HOMWOOD SUITES

3500 S. MERIDIAN

07-15-21	CITY COMMENTS
11-05-21	CITY & FRUITLAND MUTUAL WATER COMMENTS

OVERALL SITE PLAN

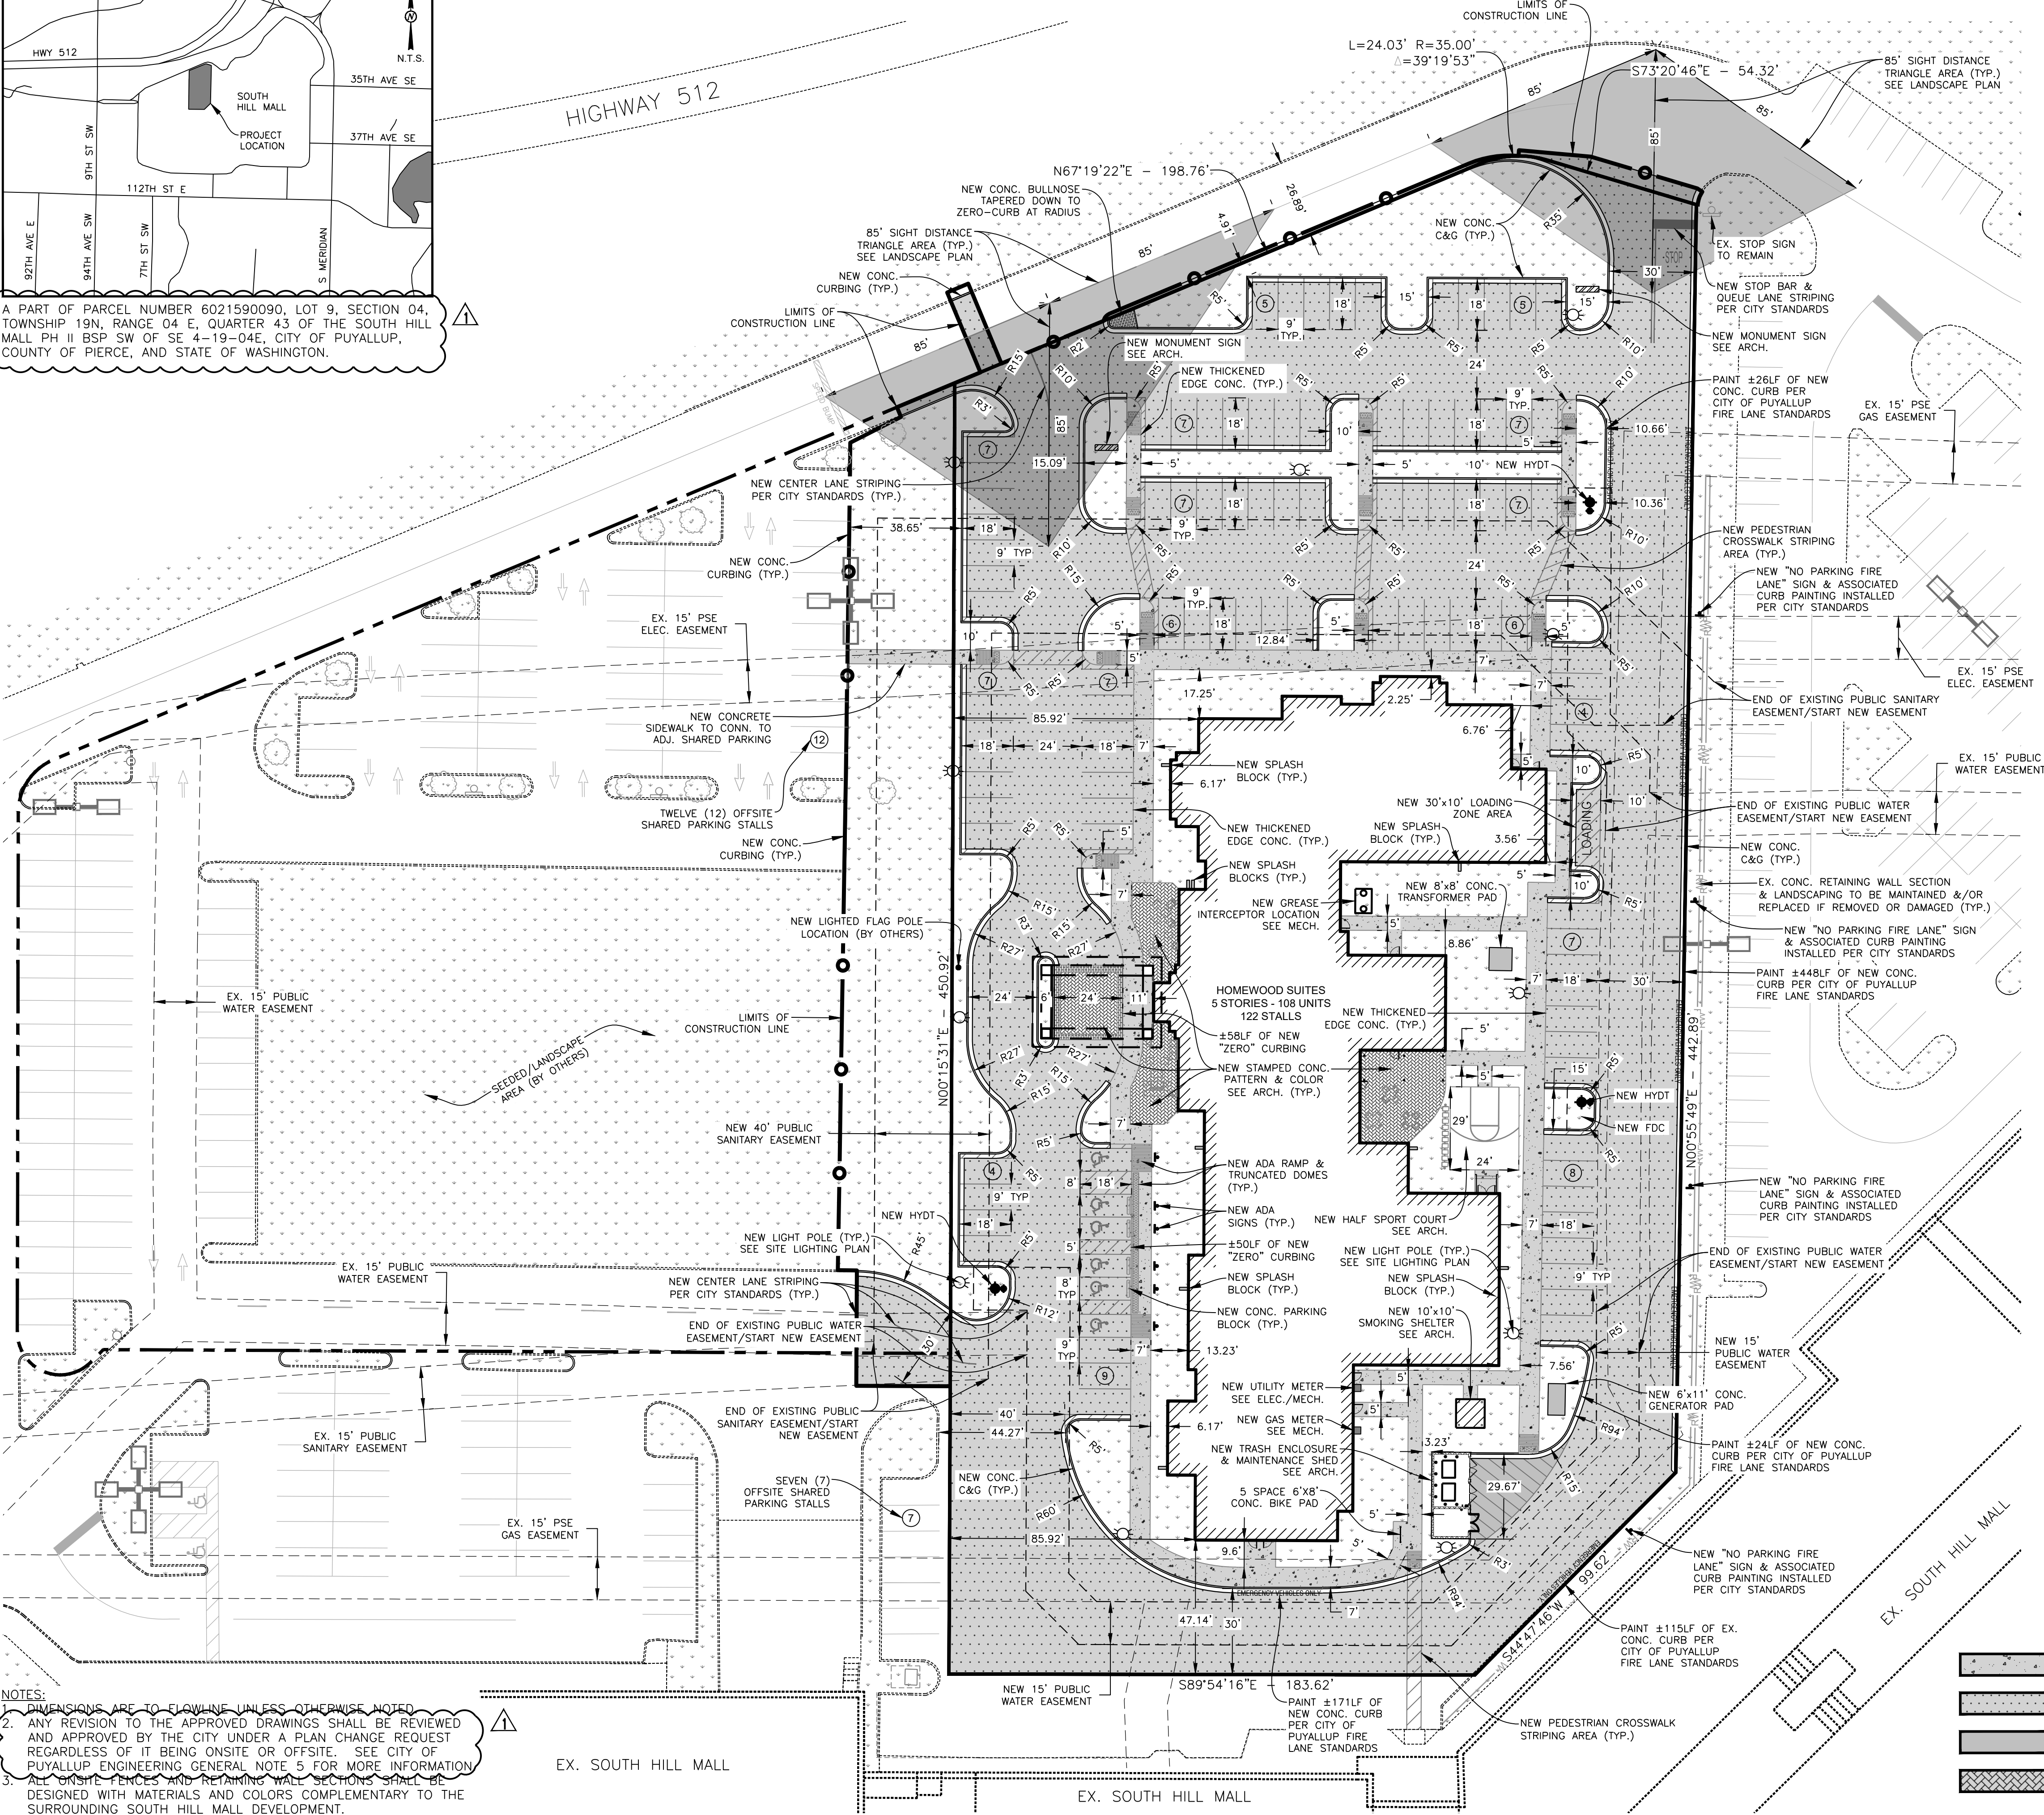
- CITY COMMENTS - 07-13-21**
 - ADDED LEGAL DESCRIPTION BELOW THE VICINITY MAP
 - REVISED PLAN APPROVAL NOTE PER CoP ENGINEERING GENERAL NOTE 5
 - ADDED PLAN SHEETS FOR THE ADA RAMP IMPROVEMENTS PIECE
 - ADDED CoP APPROVAL STAMPS
- CITY & WATER COMMENTS - 11-05-21**
 - REMOVED THE OFFSITE ADA IMPROVEMENTS PLAN SHEETS FROM THIS SET FOR SEPARATE APPLICATION/REVIEW
 - ADDED PLAN SHEETS FOR THE STORMWATER PRODUCT MANUFACTURER DETAILS

SURVEY OVERLAY & DEMOLITION PLAN
C-3

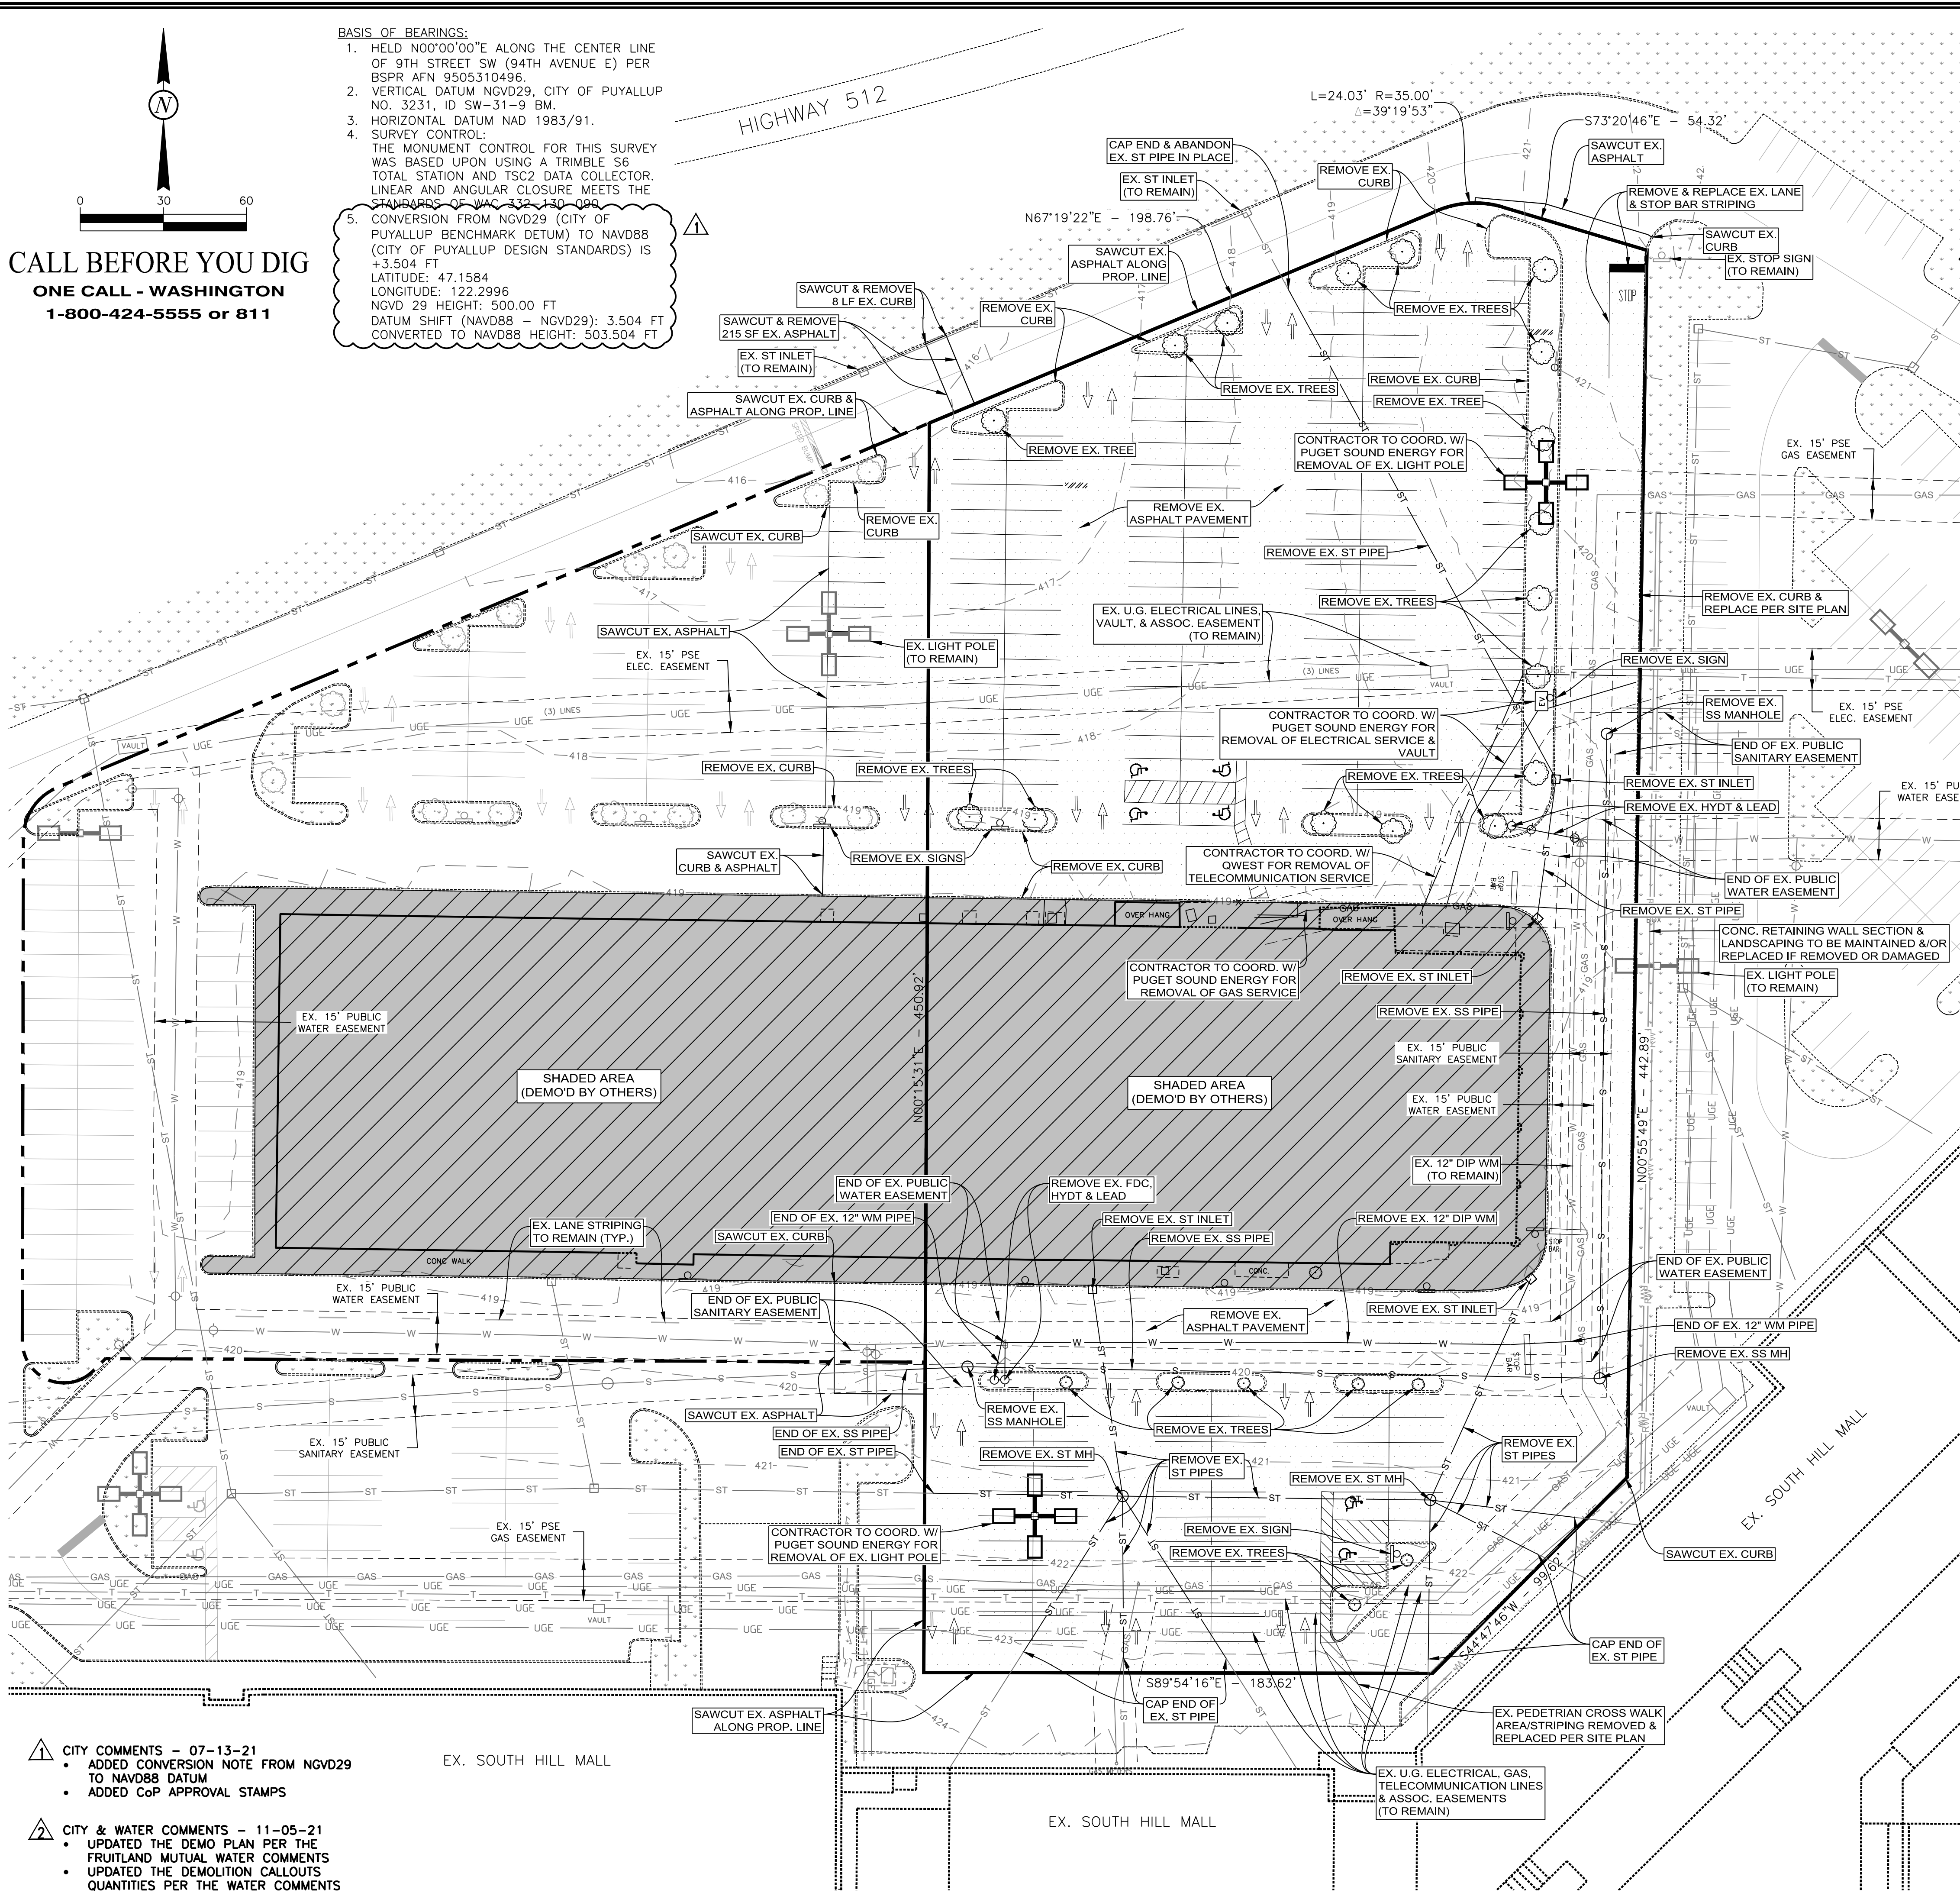
- CITY COMMENTS - 07-13-21**
- ADDED CONVERSION NOTE FROM NGVD29 TO NAVD88 DATUM
 - ADDED CoP APPROVAL STAMPS
- CITY & WATER COMMENTS - 11-05-21**
- UPDATED THE DEMO PLAN PER THE FRUITLAND MUTUAL WATER COMMENTS
 - UPDATED THE DEMOLITION CALLOUTS QUANTITIES PER THE WATER COMMENTS

SANITARY & WATER UTILITY PLAN
C-4

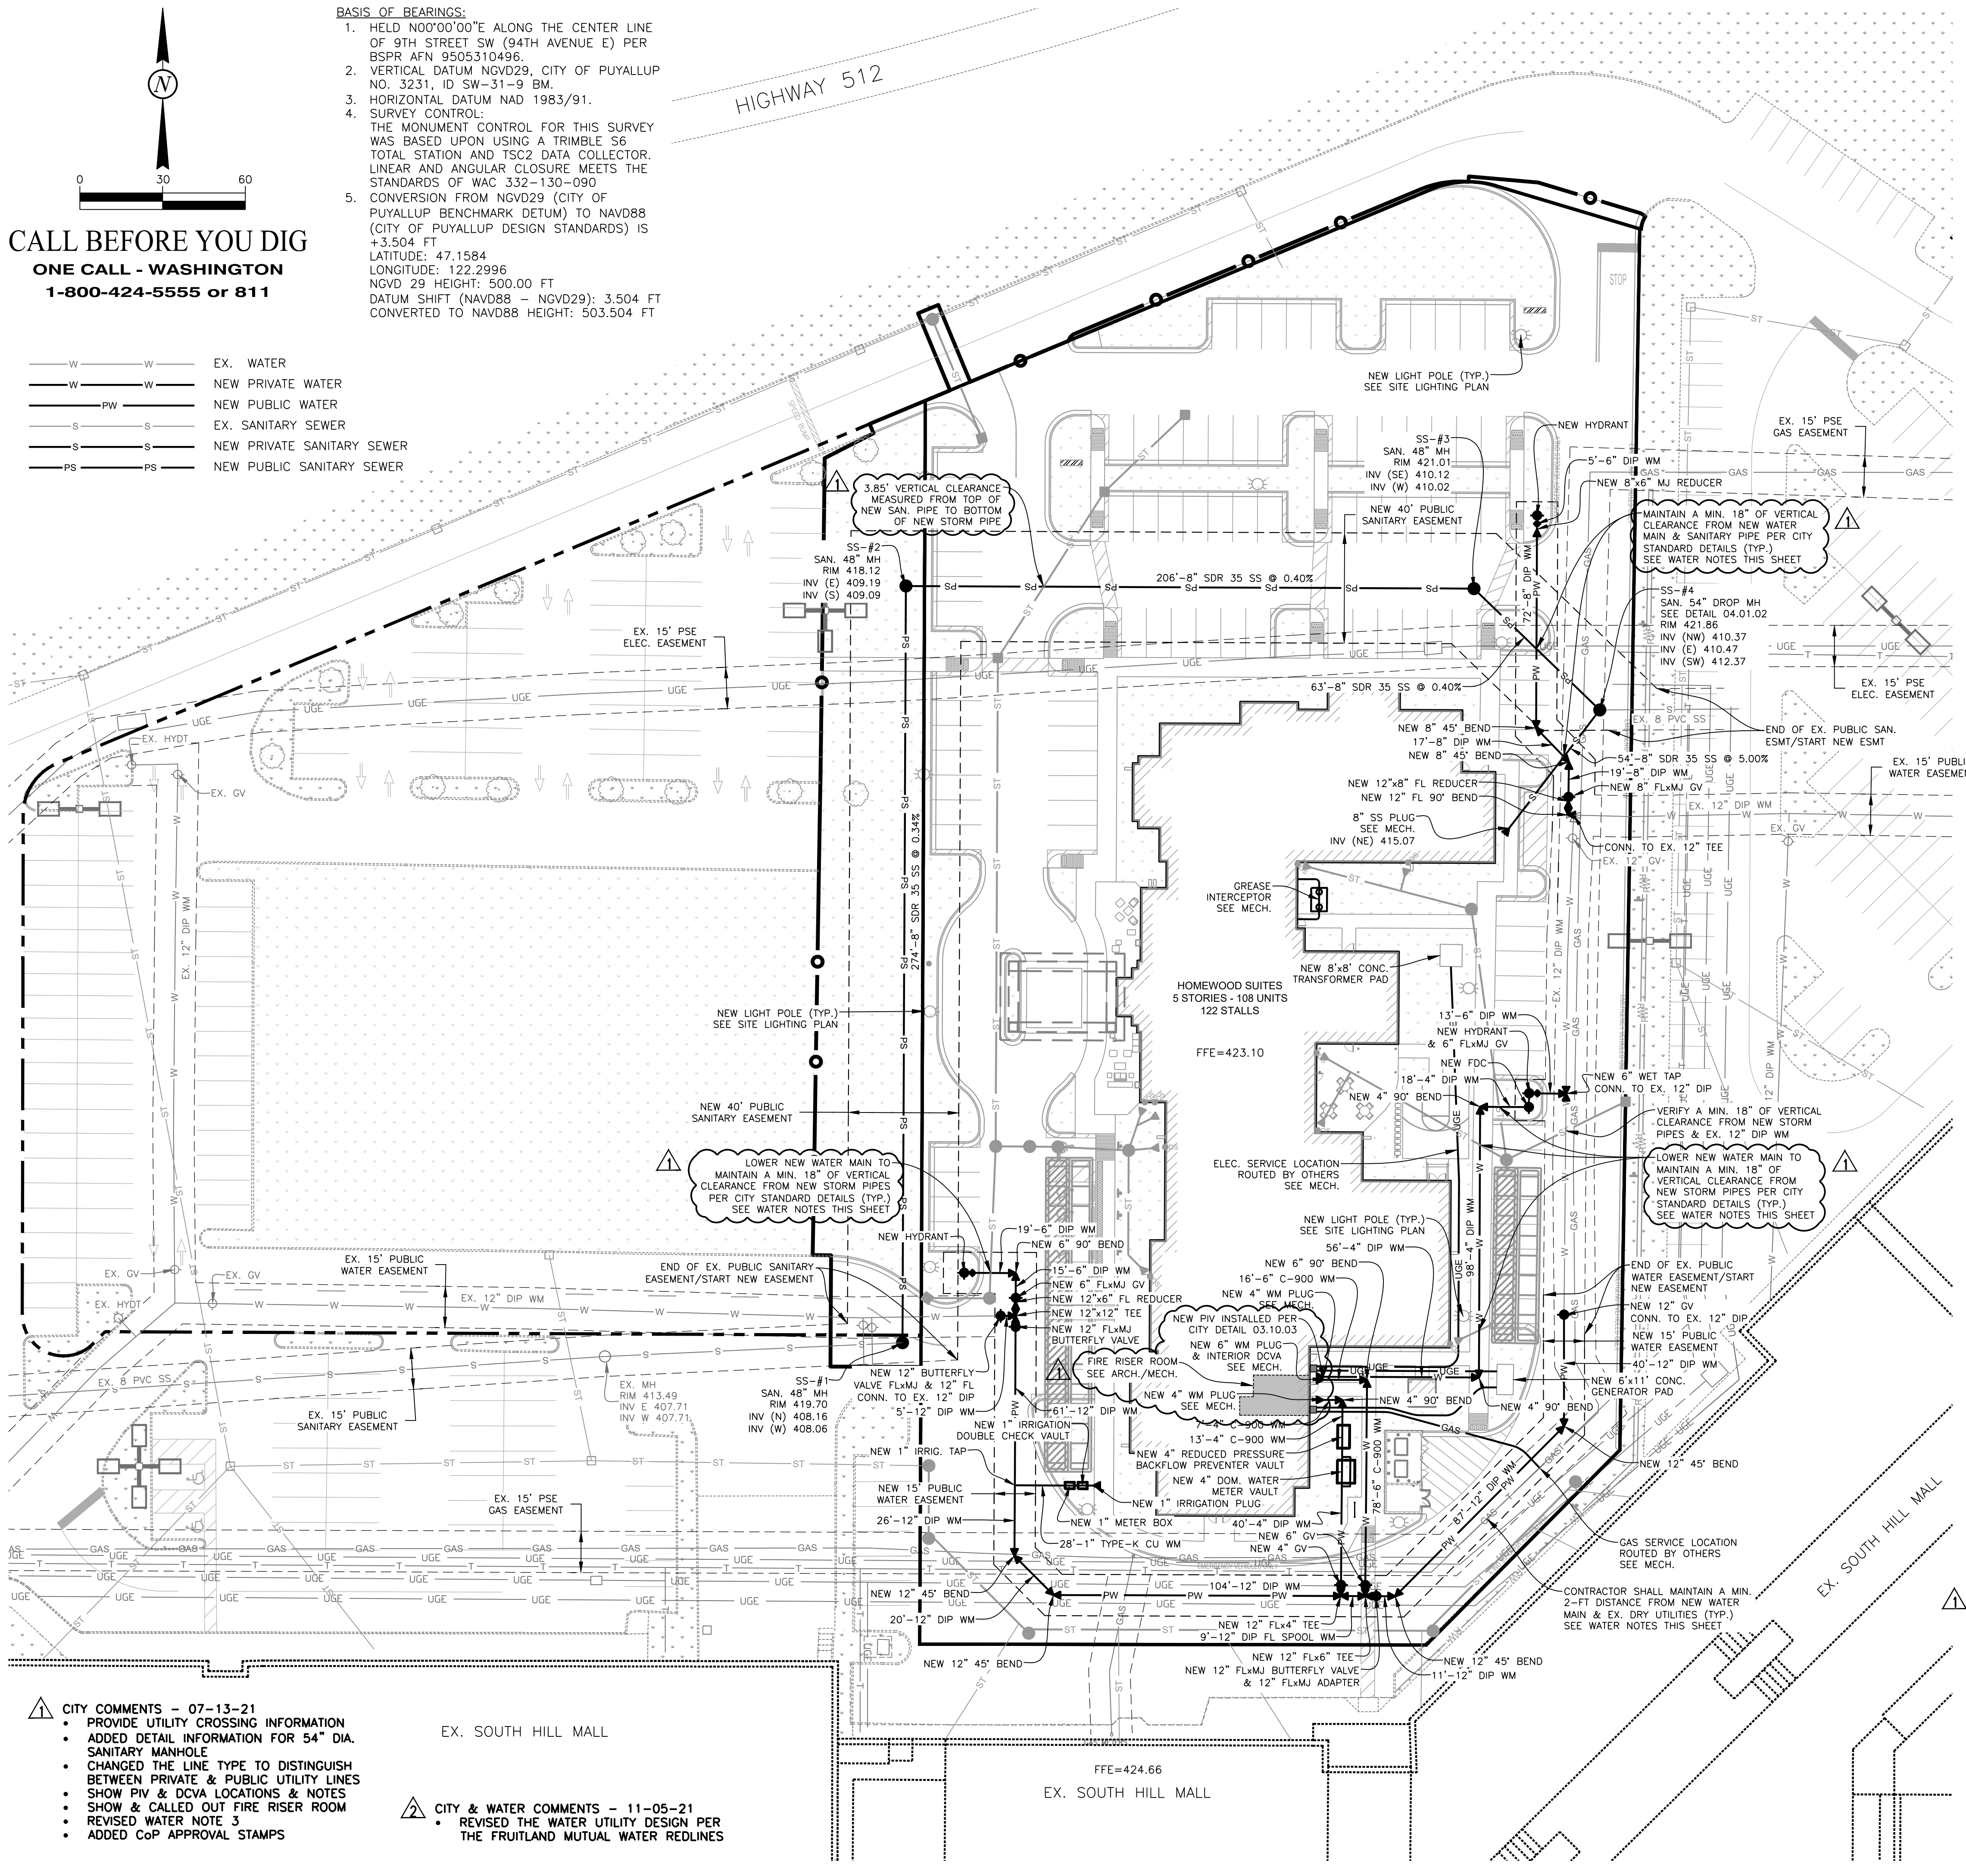
- CITY COMMENTS - 07-13-21**
- PROVIDE UTILITY CROSSING INFORMATION
 - ADDED DETAIL INFORMATION FOR 54" DIA. SANITARY MANHOLE
 - CHANGED THE LINE TYPE TO DISTINGUISH BETWEEN PRIVATE & PUBLIC UTILITY LINES
 - SHOW PIV & DCVA LOCATIONS & NOTES
 - SHOW & CALLED OUT FIRE RISER ROOM
 - REVISED WATER NOTE 3
 - ADDED COP APPROVAL STAMPS

- CITY & WATER COMMENTS - 11-05-21**
- REVISED THE WATER UTILITY DESIGN PER THE FRUITLAND MUTUAL WATER REDLINES
